UNITED STATES PATENT AND TRADEMARK OFFICE

APPLICATION NO.	FILING DATE	FIRST NAMED INVENTOR	ATTORNEY DOCKET NO.	CONFIRMATION NO.
10/797,586	03/09/2004	Shyam Kapur	7346-54US	4711
29858	7590	08/23/2006	EXAMINER	
BROWN, RAYSMAN, MILLSTEIN, FELDER & STEINER LLP 900 THIRD AVENUE NEW YORK, NY 10022			LEWIS, CHERYL RENE A	
			ART UNIT	PAPER NUMBER
			2167

Office Action Summary	Application No. 10/797,586	Applicant(s) KAPUR ET AL.	
	Examiner Cheryl Lewis	Art Unit 2167

DETAILED ACTION

FIG. 8A

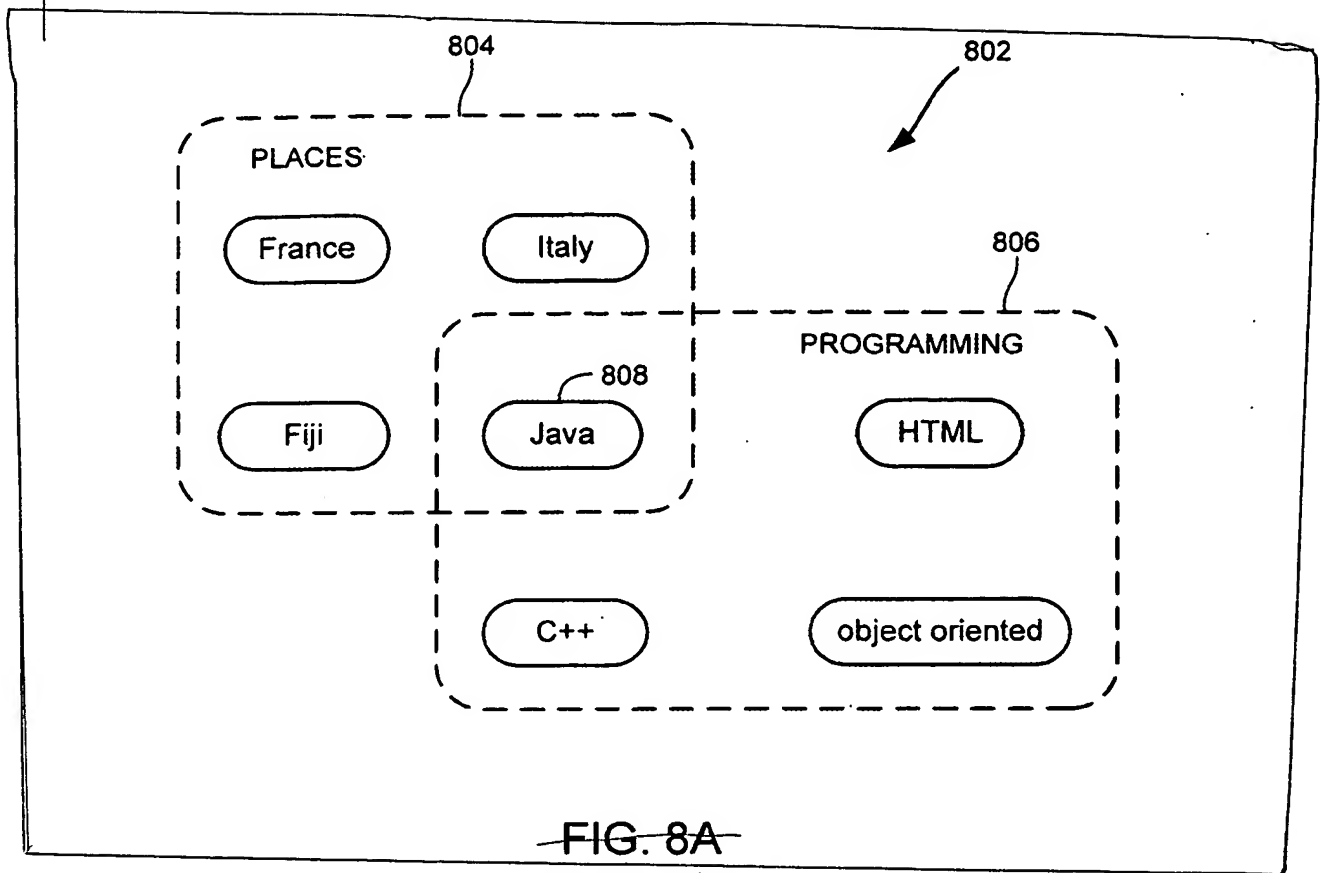
6. The drawings are objected to because drawing figures 8A-10 and 11B-12 depict a partial view of the drawing figures. A box and/or a line drawn around each individual

drawing figure is needed to show each individual figure as a separate entity (MPEP 37 CFR 1.84(h)).

As a convenience to the applicants, the examiner has attached an amendment of drawing figures 8A-10 and 11B-12 to show by example, how to effectively amend drawing figures 8A-10 and 11B-12.
